## Re: Twin Landfill Special Use Permit and Certificate of Designation Amendment 2023 at 20650 COUNTY ROAD 205, ROUTT, CO 80487

Twin Landfill, LLC dba Apex Twin Enviro (Twin) is transmitting these responses to comments from Routt County on the Engineering Design & Operations Plan for the Milner landfill. Comments received from Routt County on March 21, 2025 are listed followed by our responses in italics. An updated "clean" version of the EDOP with appendices will be provided when Twin replies to the CDPHE comments.

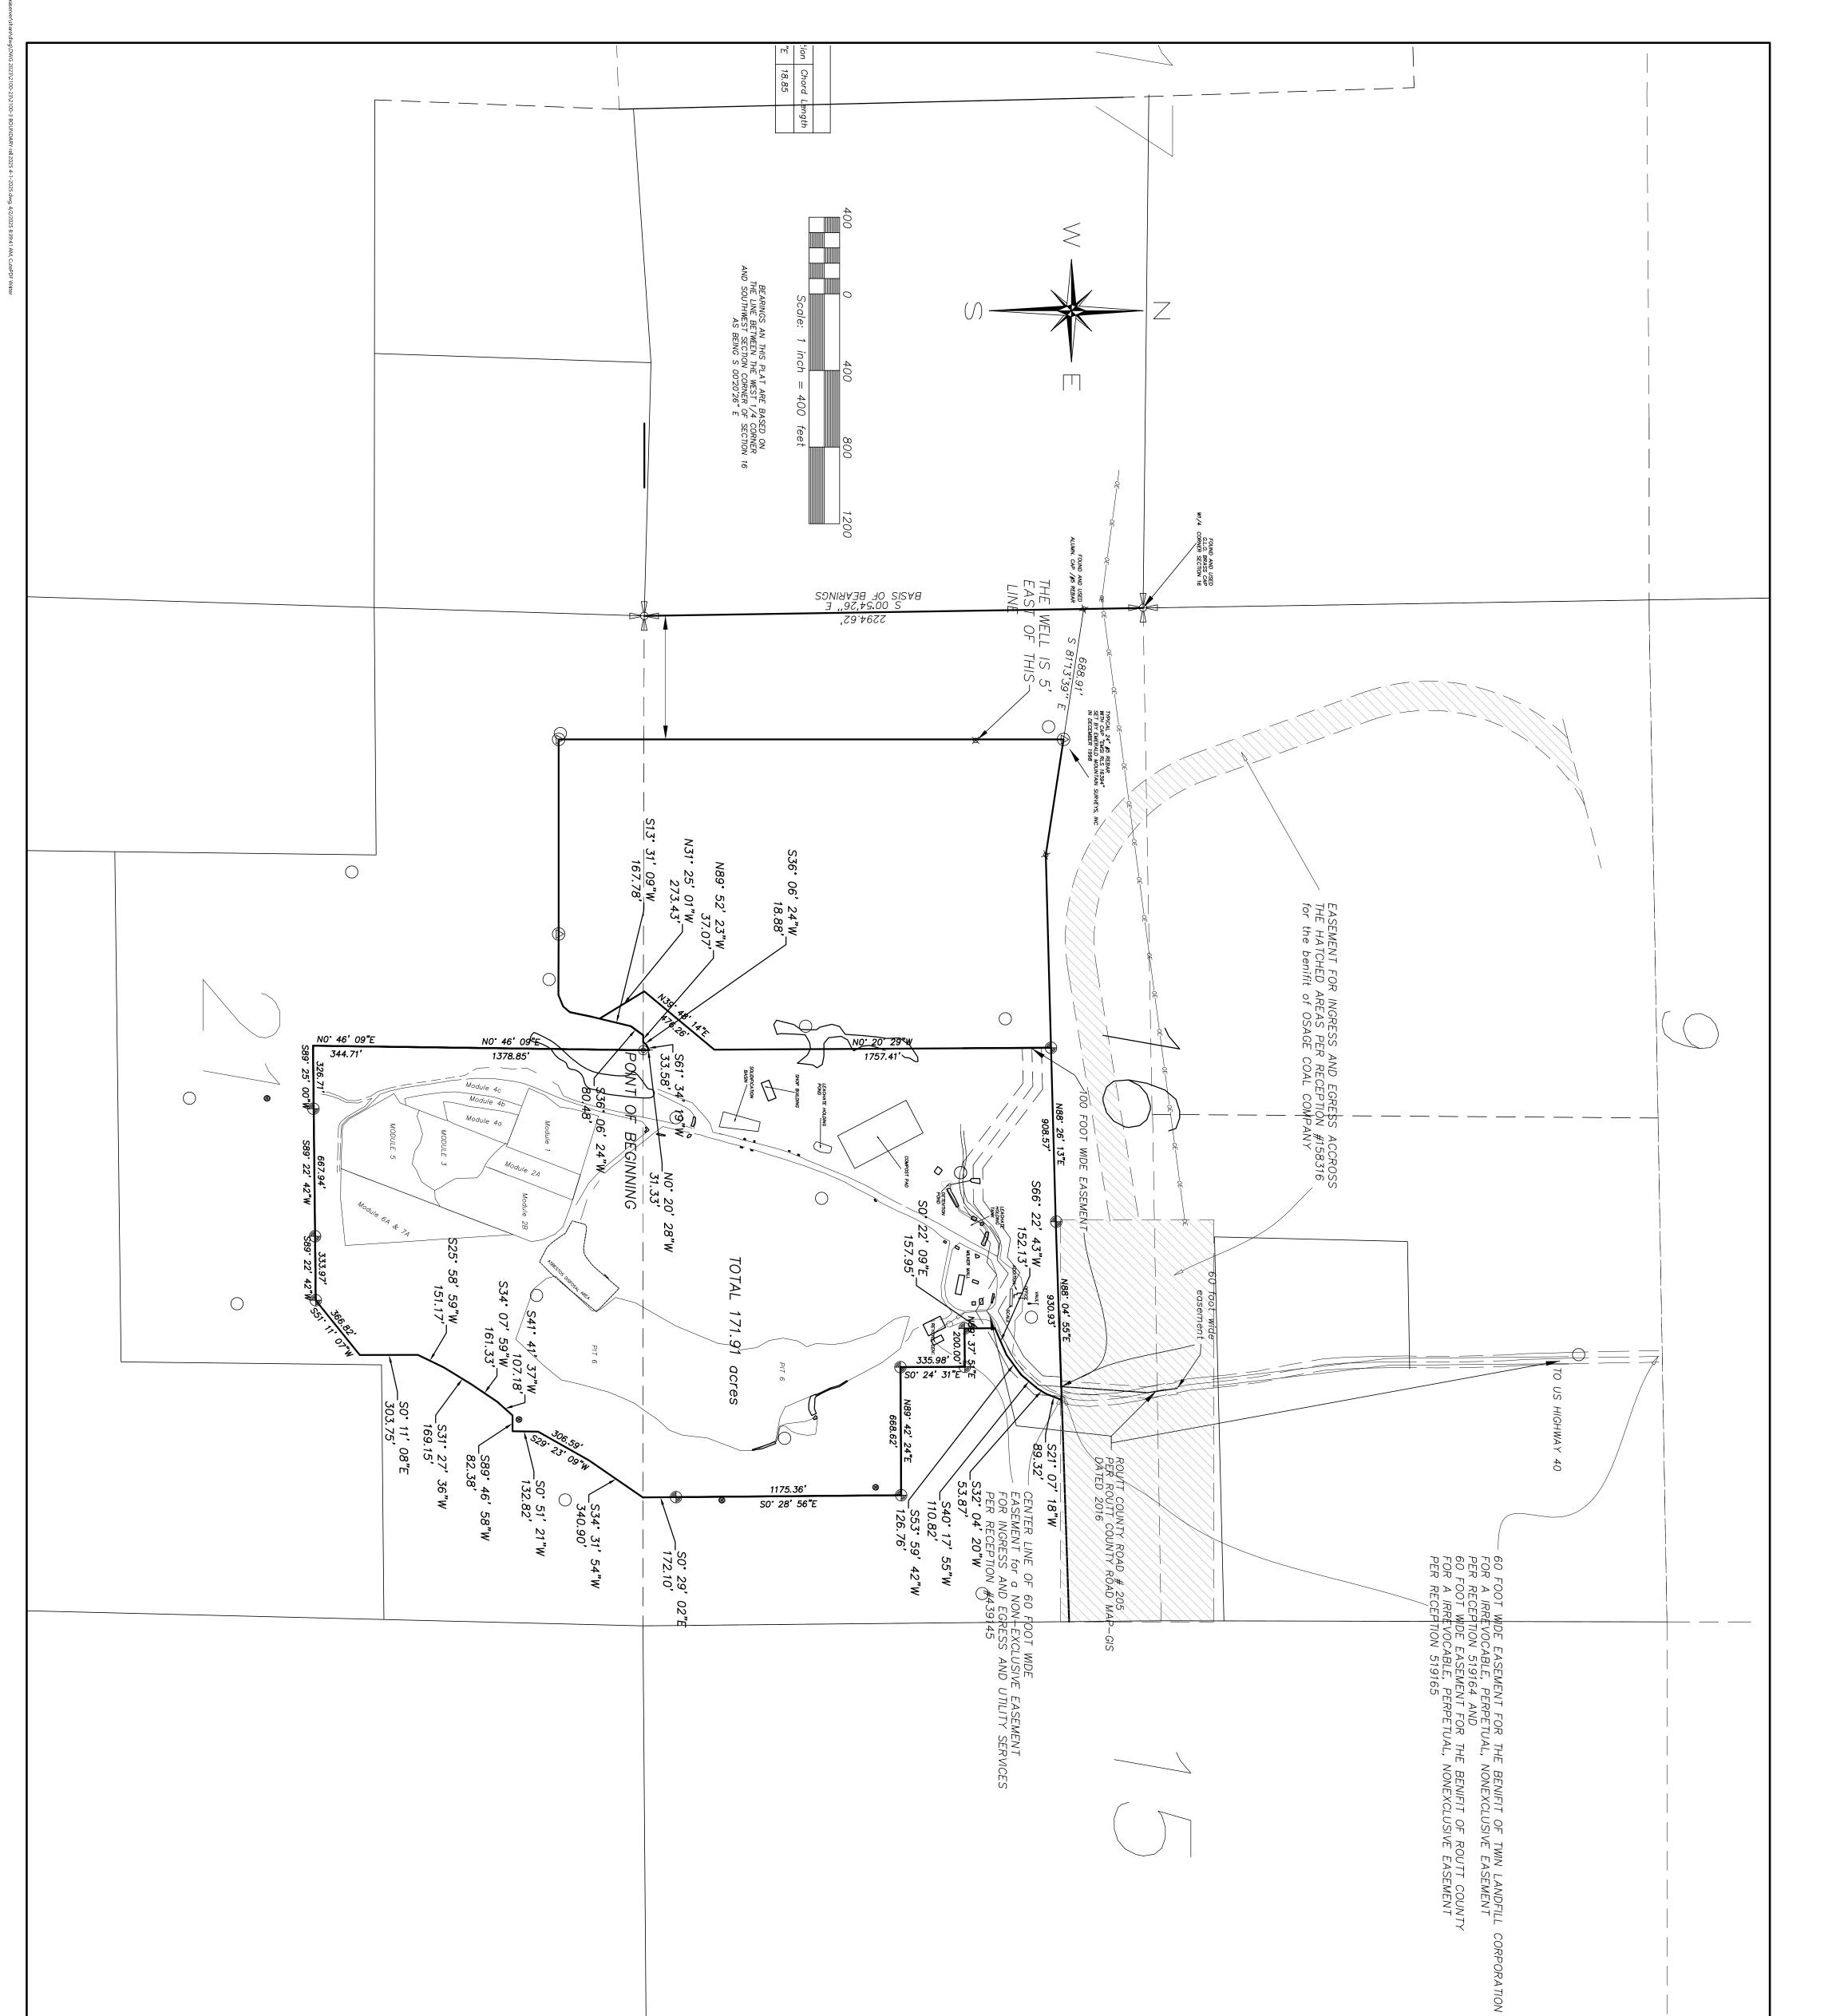
1. The current description describes three separate pieces of land. Please include a single legal description that encompasses the full CD area.

> Consolidated legal description is included in Section 1.3 of the EDOP, and attached to this letter for reference.
